IBR-0360-0014

APPLICATION FOR AN INCIDENTAL BOUNDARY REVISION
This Form Cannot Be Utilized For The Removal Of Coal
(File in Quadruplicate)

1. Permittee's Name The Ohio Valley Coal Company Phone # (614) 926-1351
2. Address 56854 Pleasant Ridge Road, Alledonia, Ohio Zip Code 43902
3. Coal Mining Permit # D-0360
4. Additional acres to be permitted 7.6
5. Has this acreage been affected? Yes _____, No x
6. Describe the reason this additional acreage is required.
Construction of pond and parking lot.
7. Describe the activities to be conducted on this area.
Construction of pond and parking lot.
8. Is the information contained in the previously approved permit application applicable to this revised area? Yes x, No _____.

Your incidental boundary revision (I.B.R.) on Permit D-0360 for 7.6 acres was received on March 5, 1993. The IBR. has been judged incomplete.

REQUESTED AREA
PRIME FARMLAND
SCALE: 1" = 1320'

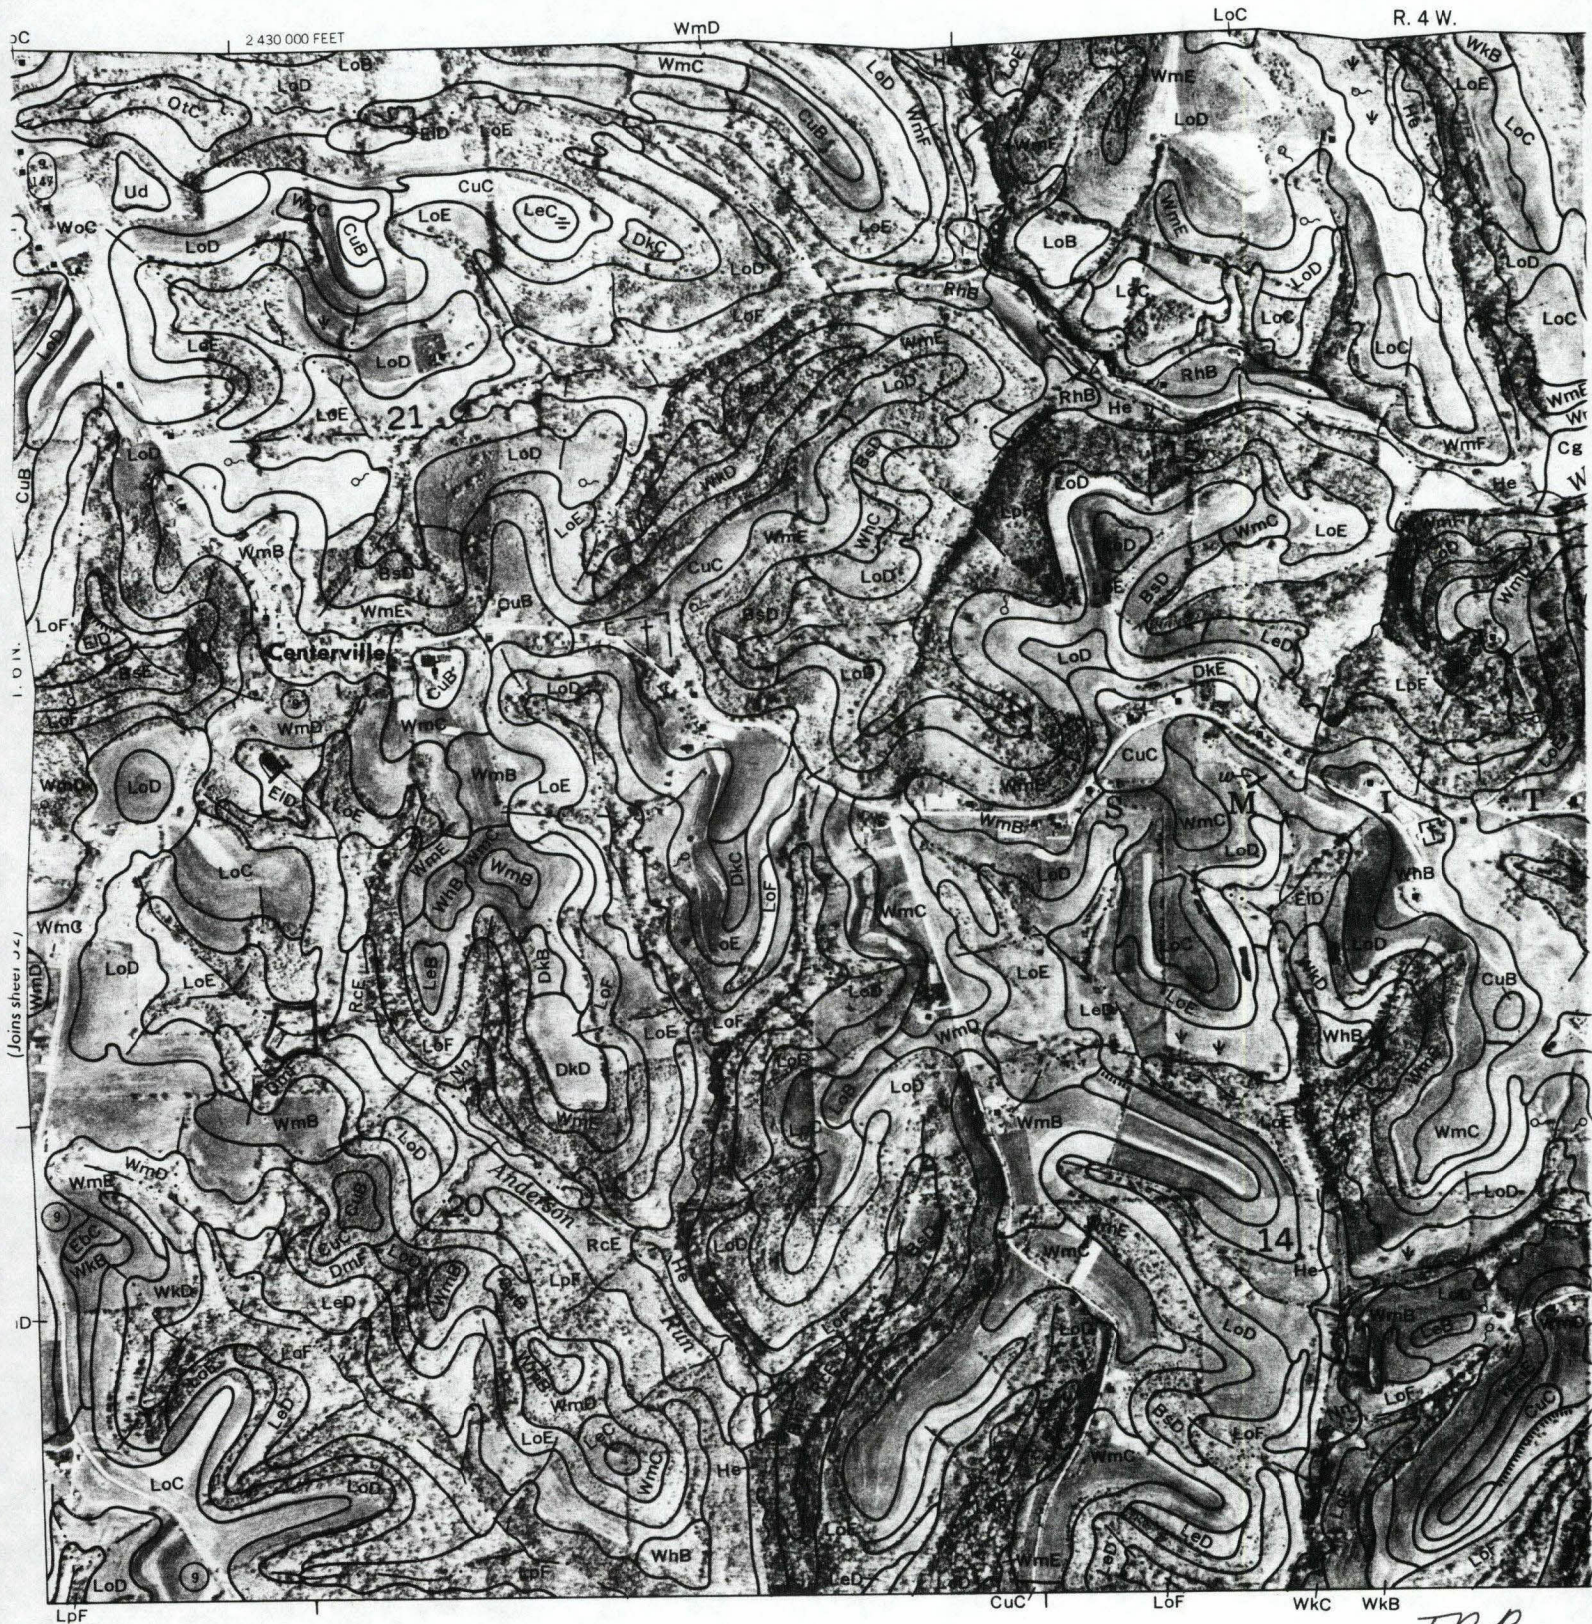
The Ohio Valley Coal Company is preparing to submit for an incidental boundary revision to our mining permit D-0360 for a small area in Section 20, Smith Township, Belmont County, Ohio. The area (7.6 acres) is shown on the attached map from the Soil Survey of Belmont County, Ohio (July, 1981), Page 53. Please determine if the area shown in red and yellow contains prime farmland. The area contains the following soil types:
